LEE'S SUMMIT
MISSOURI
Development Services Department

Development Services Staff Report

File Number	PL2023-339
File Name	PRELIMINARY DEVELOPMENT PLAN – Summit Orchards North
Applicant	Townsend Capital, LLC
Property Address	1151 NW Ward Rd, 1201 NW Ward Rd and 1231 NW Ward Rd
Planning Commission Date Heard by	February 22, 2024 Planning Commission and City Council
Analyst	Hector Soto, Jr., AICP, Senior Planner

Figure 4 - Auto dealership monument sign detail

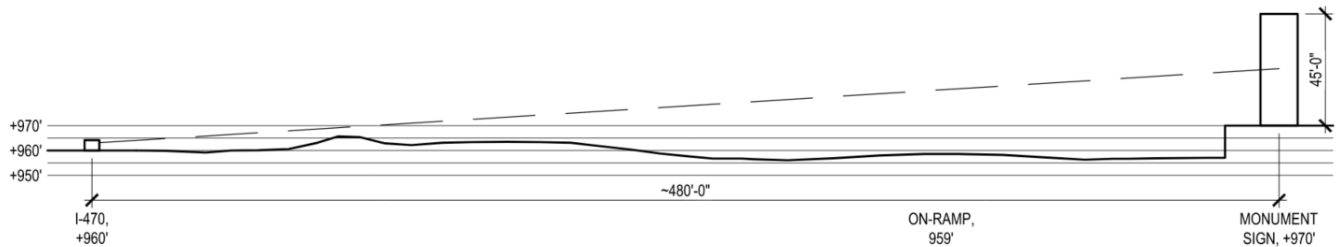
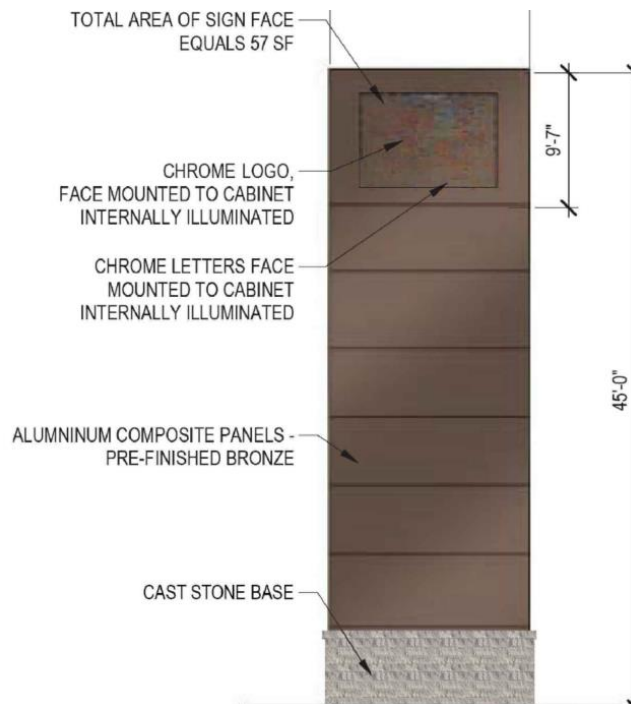
As it relates to monument signs, the applicant proposes an allowance for each of the two auto dealership sites to have one monument sign along its respective I-470 frontage for a 45'-tall sign with a total structure area of 637.5 sq. ft. compared to the UDO's typical standard of 12' height and 96 sq. ft. total structure area. The rationale for the allowance for taller and larger signs for the auto dealership sites is related to the grade differences and distance between the I-470 travel lanes and the project sites. There is a grade difference of

10' between the I-470 travel lanes and the monument sign locations. This condition taken in conjunction with the approximately 480' of horizontal separation between the travel lanes and sign locations provides a practical difficulty in providing reasonably visible signage along I-470 in strict adherence to the UDO standards for a monument sign. Staff supports the applicant's proposal for taller and larger monument signs along the I-470 frontage for the auto dealerships as depicted in the preliminary development. The applicant has provided a profile of the site to illustrate the grade difference and horizontal separation. The proposed signs will, however, comply with the allowable sign face standard of 72 sq. ft.
